PETITION TO DENY

RE: FCC File No. 167104 Vida Ministry Inc. (FCC MX Group 200)

**NEW NCE-FM for: PORT ARTHUR, TX Proposed Channel 205C1 (88.9 MHz)
 Christian Ministries of the Valley, Inc. - EVALUATION**

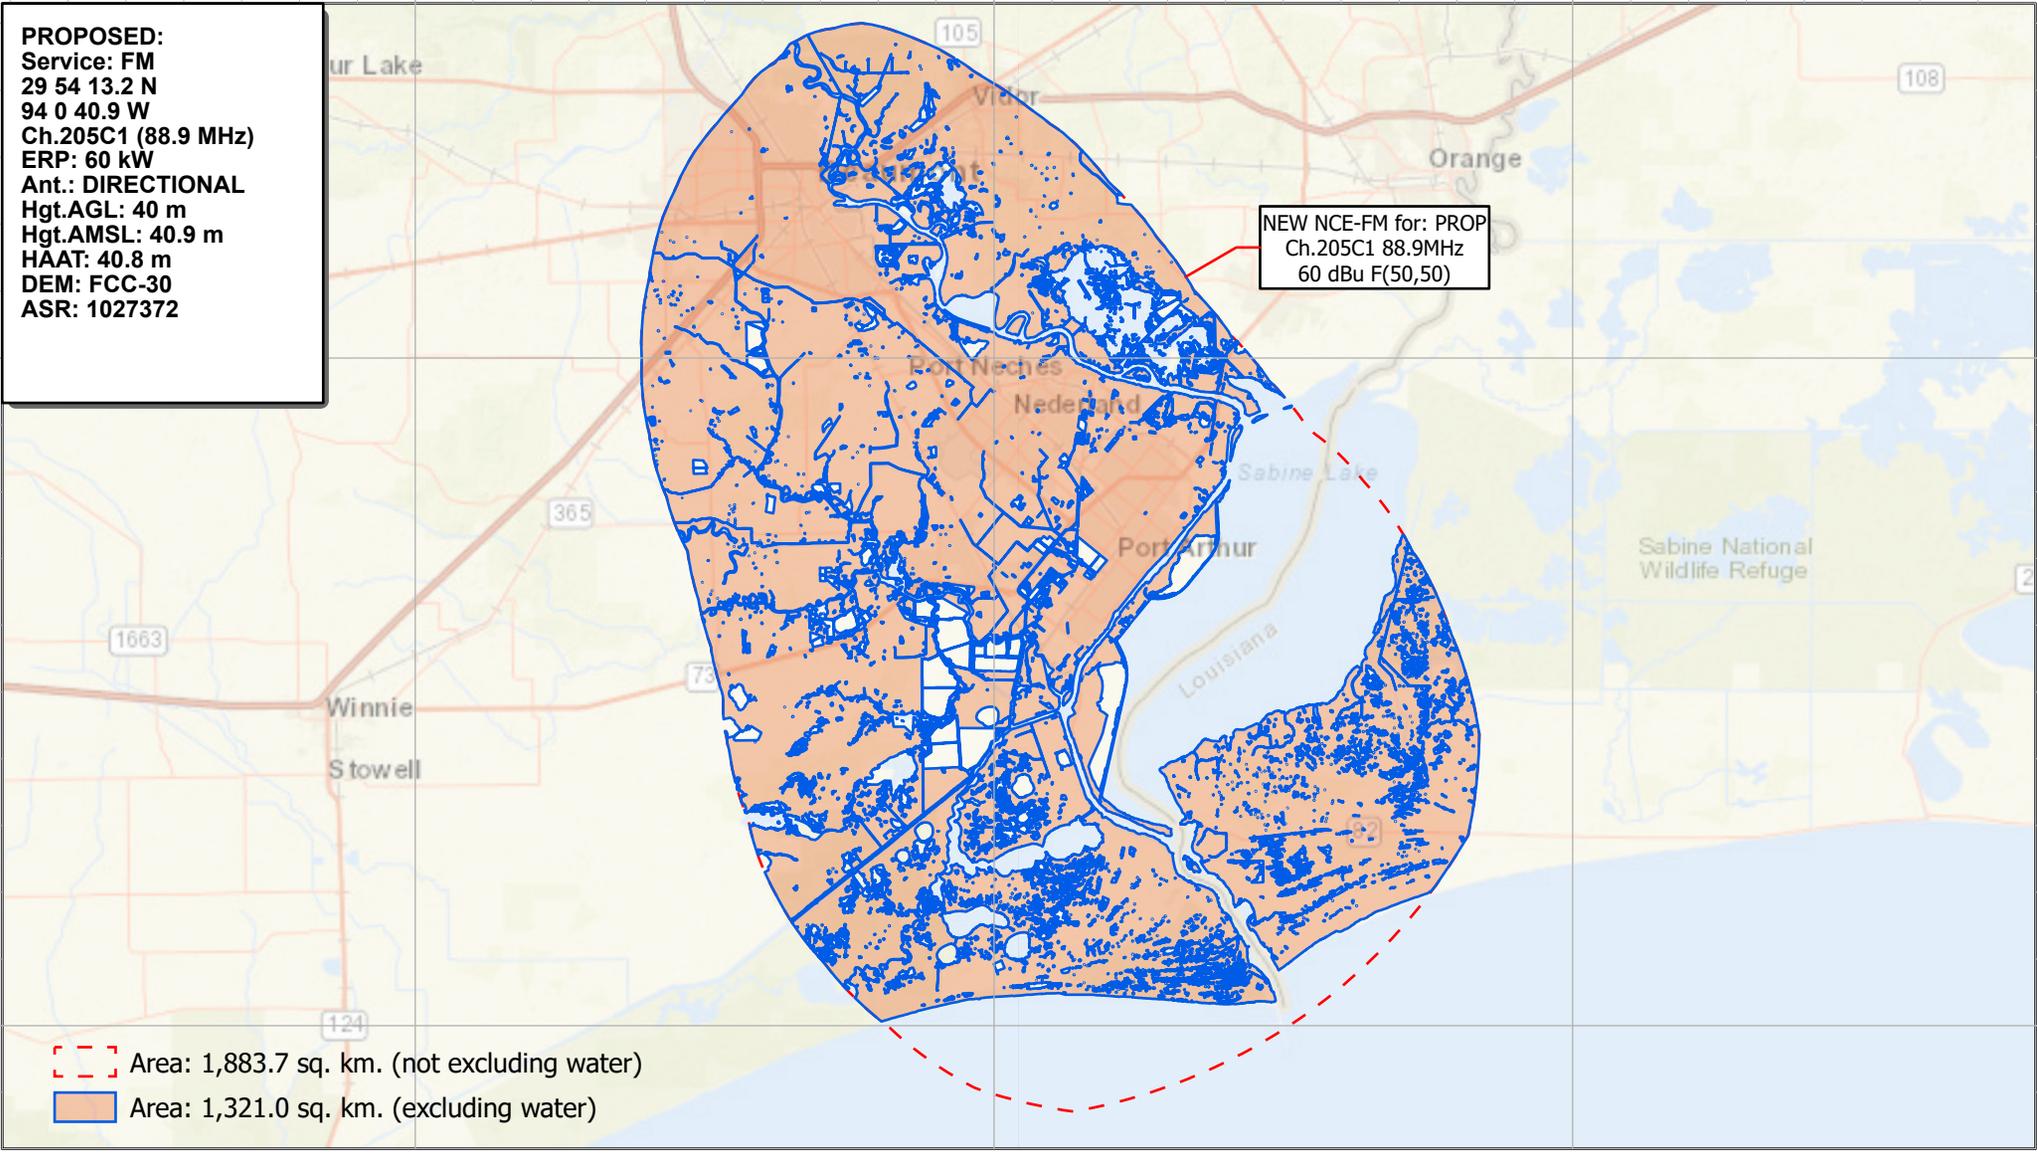
CMV's calculated "new area served" does not exclude areas of water. CMV did not provide the required exhibit explaining how it calculated the technical parameters nor did it specify the year and blocks of census information used, and the method used to determine area. CMV answered 1,881.6 square kilometers. Call's consultant attempted to duplicate CMV's calculations. First, by calculating the gross area of the entire 60 dBu contour (not excluding water) Call's consultant arrives at 1,883.7 square kilometers (which is better than 99.8% agreement with CMV's areal value). However, by subtracting 562.7 square kilometers of significant water area from the proposed CMV 60 dBu contour, the correct new area served is only 1,321.0 square kilometers. Therefore, CMV has overstated its new area served by 42.6%.

The calculated water area inside the 60 dBu contour predicted with the parameters of application file number 0000166728 is 562.7 square kilometers. The total area of the contour is 1,883.7 square kilometers. Subtracting the significant water area of 562.7 sq.km. from 1,883.7 sq.km. results in a total land area of 1,321.0 sq.km. Therefore areal coverage of 1,881.6 sq.km. claimed on application 0000166728 did not account for significant areas of water in the areal coverage calculation and overstated the value by 562.7 square kilometers (+42.6%).
